Hemphill Diversion Structure Project

Final Environmental Impact Report
SCH # 2020090032

Nevada Irrigation District

July 2021

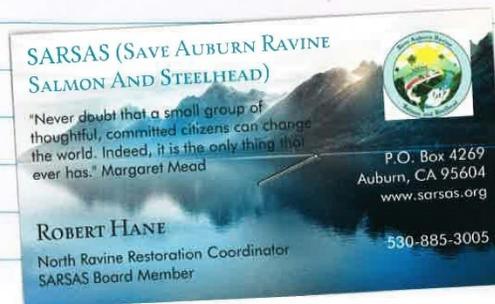
With the use of concrete pre-fabricated concave weirs we feel there would be better stability to the roughened rock ramp. Also, we feel that fish passage at all water flows would provide for better fish passage.
